TYPICAL WALL SECTIONS
 DOOR & WINDOW DETAILS
 MISCELLANEOUS DETAILS
 RENT THREE BRICK APARTMENTS
 A 240 UNIT COMPLEX
 ADDISON
 PULSON INVESTMENTS INC. CHAIR DEVELOPER
 RAWLS & WELTY
 ARCHITECTS PLANNERS
 4825 RED BERRY SUITE 225
 DALLAS TEXAS 75244
 CITY OF ADDISON
 APPROVED AS NOTED
 FOR CONSTRUCTION
 12-2-77
 CONTRACTOR IS HEREBY INSTRUCTED TO
 BE THE CASE IN ALL CASES EXCEEDING ALL RE-
 QUIREMENTS OF BOTH NATIONAL AND LOCAL CODES
 AND/OR ORDINANCES APPLICABLE TO HIS WORK
 APPROVAL OF THESE DRAWINGS SHALL NOT BE CON-
 SIDERED TO RELIEVE RESPONSIBILITY OR IMPLY
 WAIVER TO SUCH CODES.
 DR BY: KLB
 CHK BY: JKL
 REVISIONS:
 1 4/77
 JOB NO. 12001
 DATE: 11-1-77
 SHEET NO.
 18
 OF 24 SHEETS

SITE PLAN

BENT TREE BROOK APARTMENTS

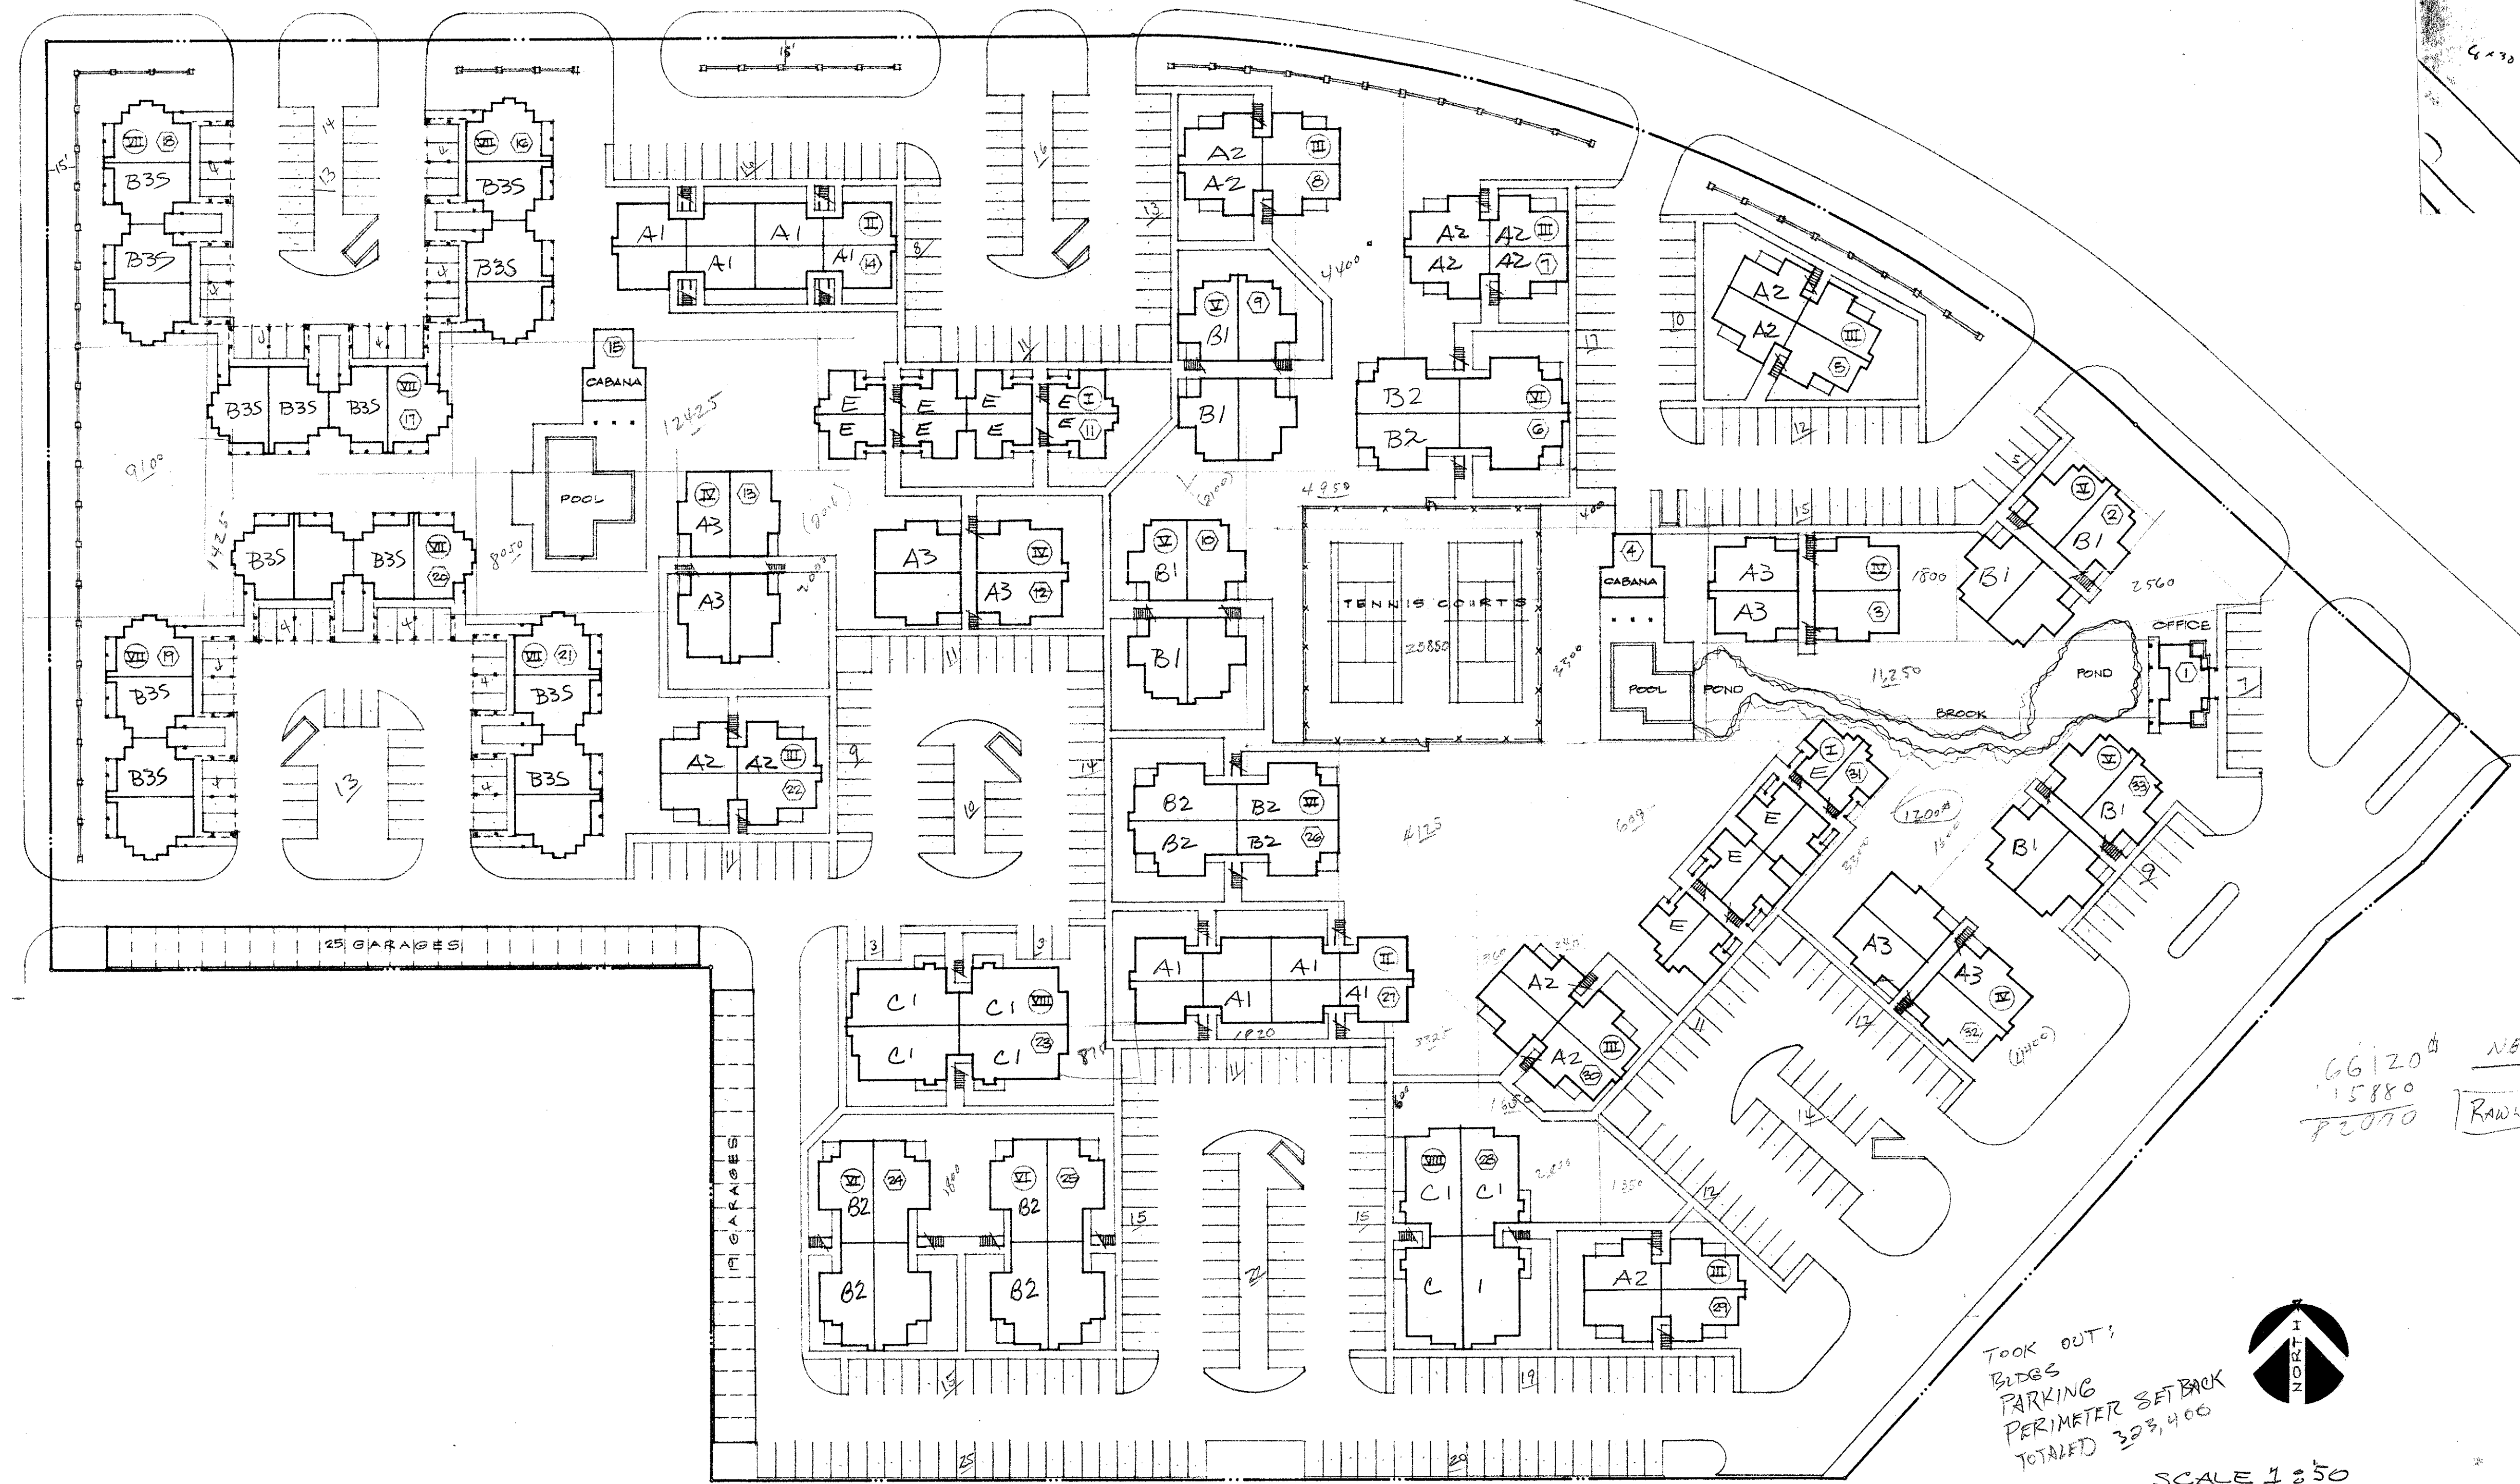
10-26-77
 John,
 for your
 preliminary review of
 contact you about floor plans
 Jerry M. Williams
 PH 243-7441

To Be Revised!

Took OUT:
 BLDGS
 PARKING
 PERIMETER SETBACK
 TOTALLED 323,400
